1860 Bayview Avenue Rezoning and Site Plan Control Applications - Request for Direction Report for Ontario Municipal Board Hearing

Date:	July 4, 2011
To:	City Council
From:	City Solicitor
Wards:	Ward 25, Don Valley West
Reason for Confidential Information:	This report is about litigation or potential litigation that affects the City or one of its agencies, boards, and commissions and this report contains advice or communications that are subject to solicitor-client privilege.
Reference Number:	10 255840 NNY 25 OZ & 10 276757 NNY 25 SA

Attachment 5: Site/Ground Floor Plan as revised

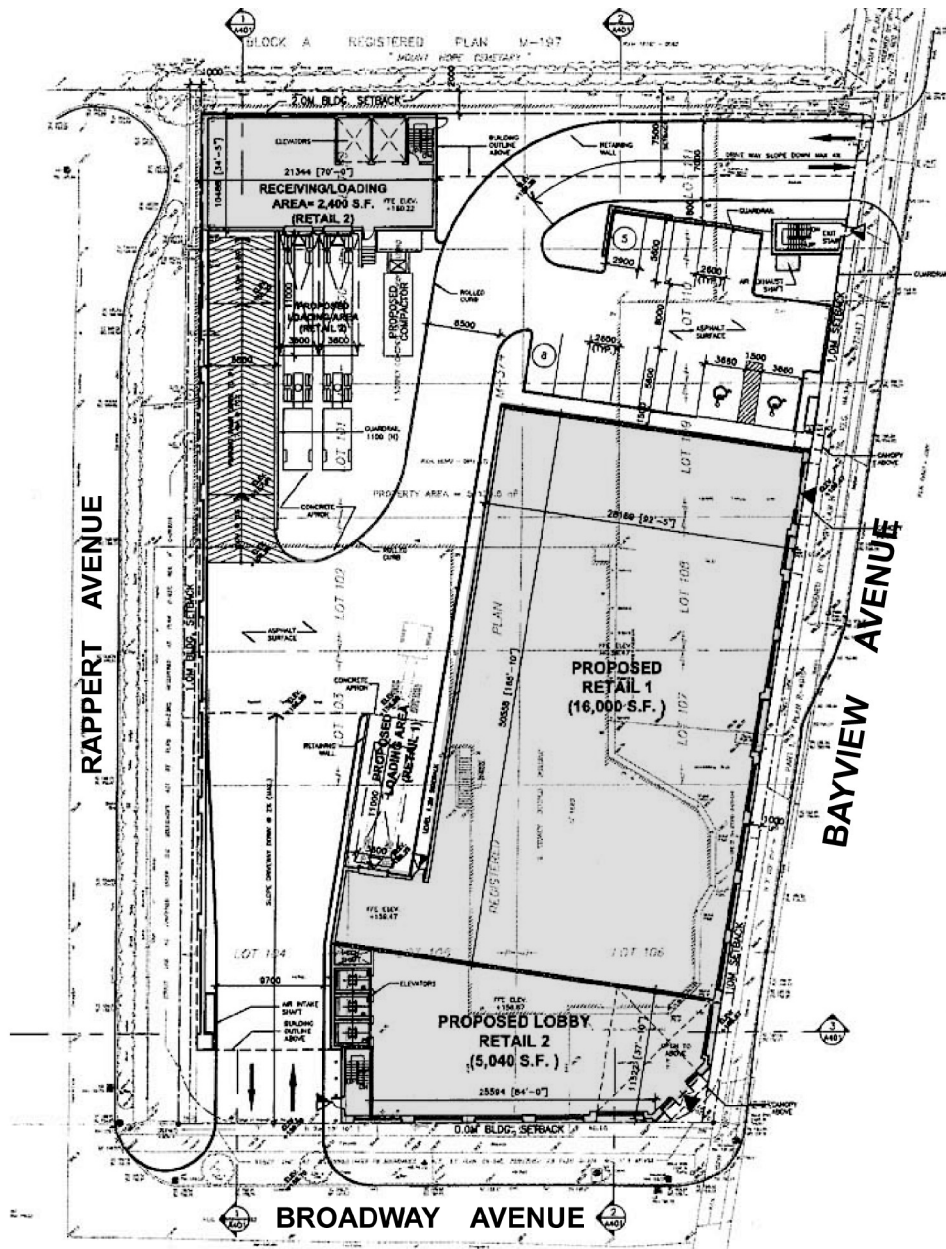
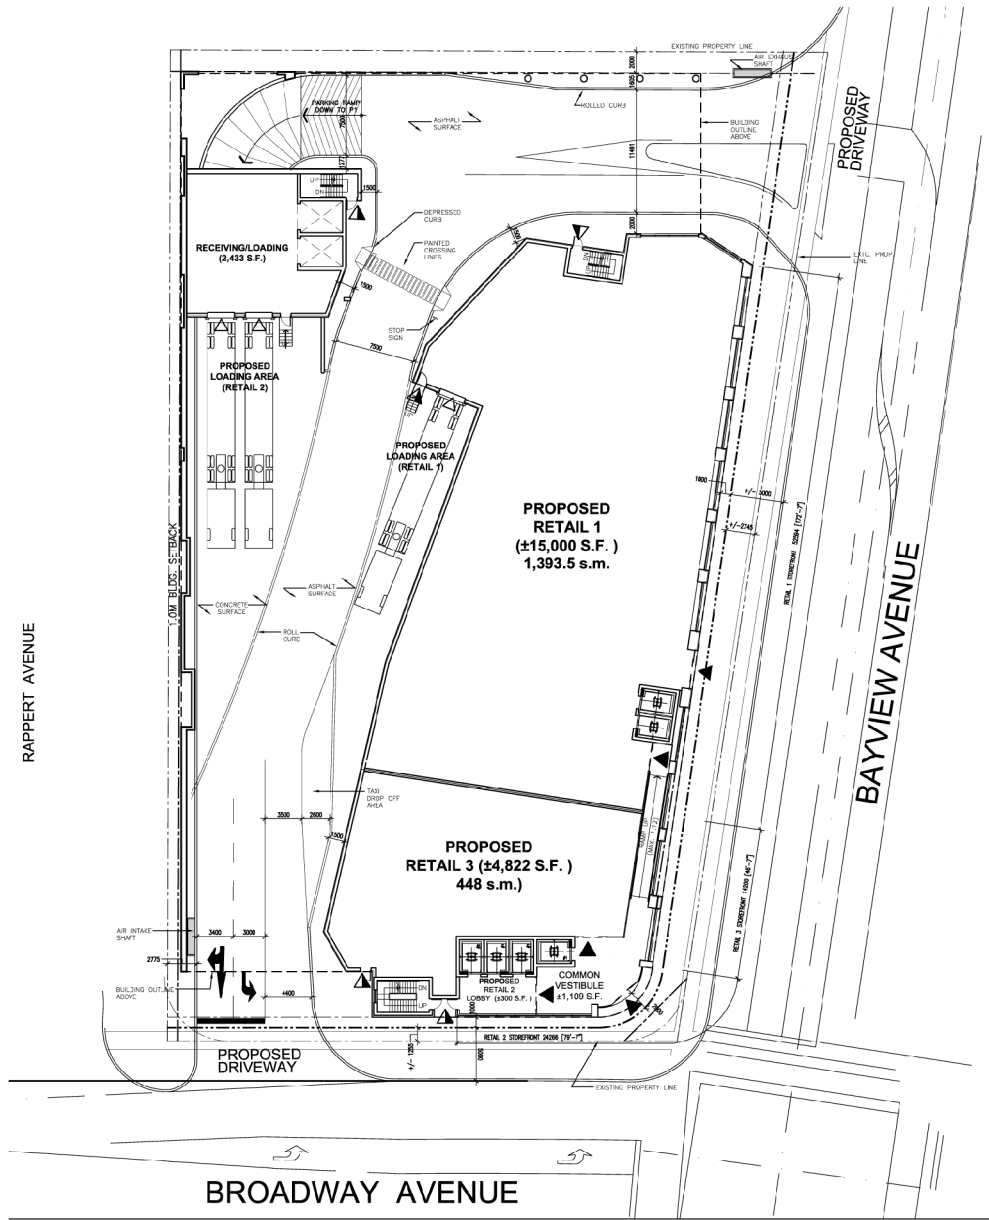
In order to mitigate the potential vehicular conflicts at the parking ramp and internal driveways, stop controls must be located at the egress of the parking ramp and the Broadway Avenue driveway aisle north of the loading area and the applicant will need to address sight line obstruction issues.

As proposed, the development would have two loading areas accommodating 3 loading spaces to service the ground floor and second floor independently of each other. The loading areas are separated by an internal roadway that also allows access to and from the below grade garage for customer vehicle parking. As originally proposed, access to the loading areas required delivery vehicles to enter either from Bayview or Broadway Avenues, depending on which loading area they would service (refer to Site/Ground Floor Plan, Attachment 1).

Transportation staff is concerned about the possibility this creates for vehicular conflict as both delivery vehicles and passenger cars would be travelling in both a north and southbound direction. Transportation staff recommends that all loading/commercial vehicles access the site from Bayview Avenue and exit the site from Broadway Avenue. This will minimize conflict with passenger traffic and loading traffic.

Ground Floor Plan (Drawing No. A201)

1. As part of the proposed development, the owner is prepared to dedicate to the City a strip of land approximately 2.745 metres in width along the entire Bayview Avenue frontage to allow for a widening of the boulevard on Bayview. This dedication would allow for a left turn lane into the site and enable streetscaping to be provided along the boulevard. In addition, the owner is prepared to dedicate to the City a strip of land approximately 1.255 metres in width along the entire Broadway Avenue frontage. This dedication would allow for the widening

- of the traveled portion of Broadway and enable a proper right turn movement into the site.
2. The dimensions of the proposed building have been reduced by approximately 2.745 metres in width and approximately 2.255 metres in length. These reductions allow for an increase in the setback from the existing property line on Bayview Avenue to the proposed building face, from 1 metre to approximately **3.745 metres**, and an enlarged boulevard of 5 metres. Along the Broadway Avenue frontage, the proposed setback from the curb to the proposed building face has been increased to **6.0 metres** and the proposed setback from the existing property line has been increased from 0 metres to approximately **2.255 metres** to allow for landscaping. In addition, the northeastern portion of the proposed building has been extended northerly to provide a consistent 2 meter setback from the north property line.

3. As a result of these revisions as well as certain interior revisions as shown on the plans, the proposed gross floor area of the building has been decreased from 7,089.5 m² (76,311 ft²) to **6,831.27 m² (73,533 ft²)**, and the lot coverage has decreased from 87.8% to **83.16%**. In addition, the Floor Space Index has also decreased from 1.38 to **1.32**. (Note that these figures continue to be calculated on a pre-dedication basis.)

4. The number of potential retail units within the building has been increased from 2 to 3 units. Specifically, the parking area previously proposed on the ground floor has been deleted and replaced with the third retail unit.

5. The proposed lobby has been revised to provide for a common vestibule that allows internal access from the below grade parking areas to each of the retail units. Elevators for each of the units that provide direct access from the parking areas would also be provided.

6. The internal vehicular circulation area has been revised by relocating the access ramp to the below grade parking garage from west of the proposed loading docks for Unit 2. The garage access is now proposed at the northwest corner of the building with a "T" intersection, together with appropriate signage and pavement markings.

7. The foregoing allows for direct vehicular access between Bayview Avenue and the below grade parking garage, and minimizes the extent of vehicular and truck circulation interaction. The loading areas have also been revised to allow all delivery trucks to now access the building from Bayview Avenue and exit onto Broadway Avenue. Moreover, in order to allow for safe truck movements, the access on Bayview Avenue has been increased from 7 metres to **11.491 metres** and the access on Broadway Avenue has been increased from 9.7 metres to approximately **10.8 metres**.

8. In order to properly guide pedestrians and vehicles, the revised plans contemplate proper signage, pavement markings and walkways to restrict pedestrians from entering the loading areas and to allow for safe pedestrian circulation throughout the rest of the building.

9. A taxi drop off area is now being proposed next to the Broadway Avenue access.

10. A 2 metre landscape buffer is now being provided along the northern property line.
11. A 1 metre weather canopy will be provided along the Bayview Avenue frontage.
12. A left turn lane into the site has been added.

Attachment 2: Elevations as submitted

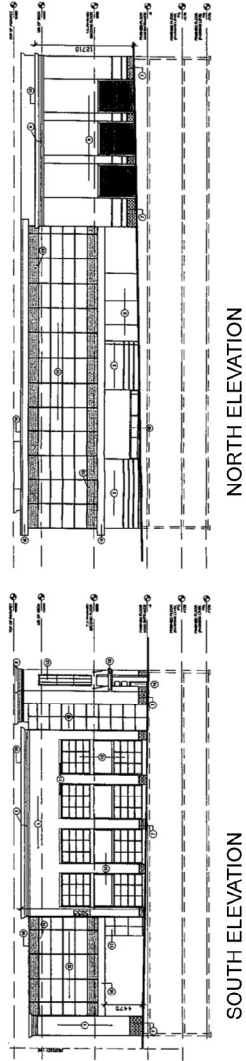
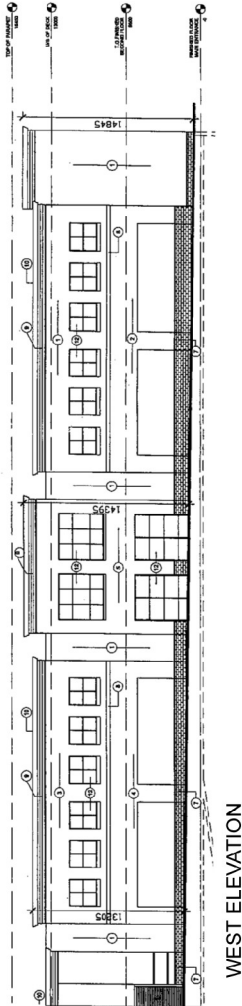
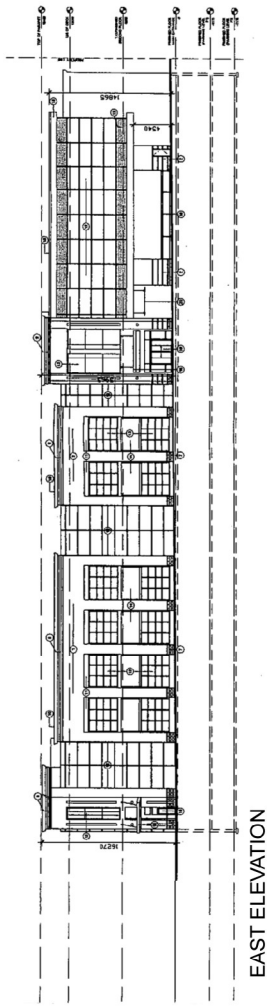
As noted above, it is recommended that the design of the proposed building be revised to better recognize the prominence of this corner site and to respond to the scale of the surrounding buildings. Revised elevations and landscape plans are to be provided by the applicant. The following discussion identifies some of the further issues that are to be addressed in further submissions, and worked out with Planning Staff as the details of the Site Plan approval are finalized.

Opportunities exist to create a more appropriately scaled and high quality façade along all frontages. Building facades need to be articulated using high quality materials and glazing to provide interest, prominence and safety to pedestrians walking along the street.

In regard to the elevations facing Rappert Avenue, the use of hand scaled masonry and smaller scale panels, fenestration and cornice detailing which reflect the finer grain detailing, height and rhythm of the residential houses on Rappert Avenue is recommended. Landscape treatment such as trellis and vines growing along the building elevations facing both Rappert Avenue and Mount Hope cemetery are recommended to soften the building edge.

For elevations facing Bayview Avenue and Broadway Avenue additional architectural emphasis at the corner and along the façade is recommended to enhance the prominence

of the corner and give the building façade more depth and interest. An overhang or continuous canopy is recommended along both the Bayview and Broadway façade, providing continuous weather protection for pedestrians walking along the commercial street edge.
